SEB Issue List Regarding APR 1400, FSAR 3.4.2 “Analysis Procedures”

Issue #1 (AI 3-79.1)

RESPONSE TO REQUEST FOR ADDITIONAL INFORMATION

RAI No.: **75-8023**

Figure 1

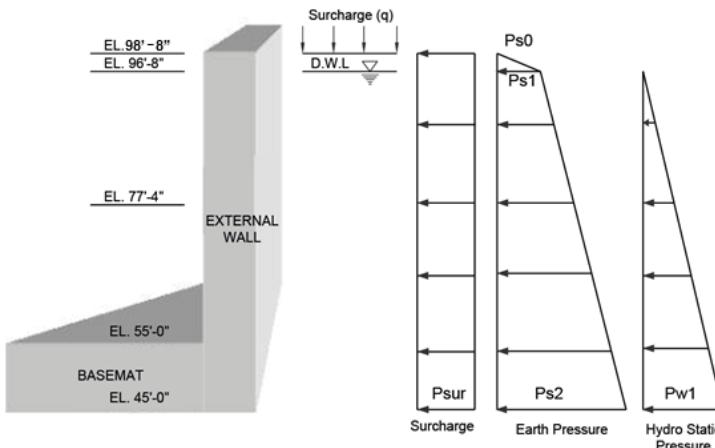
- b. How are those various water heads transformed into hydrostatic or hydrodynamic loadings (including buoyant forces)? [such as hydrostatic load, (L_h), Flooding load, (Y_f), Design flood/precipitation, (H), PMF/PMP, (H_s). Hydrodynamic load in seismic loads (E_s)—See Sec. 3.8.4.3.and Table 3.8-9A, Footnote (2)]

Soil and Surcharge loading is calculated as a linearly distributed pressure on the external walls depending on the design water level (EL. 96'-8") according to the basic equation of hydrostatics as shown in Figure 1.
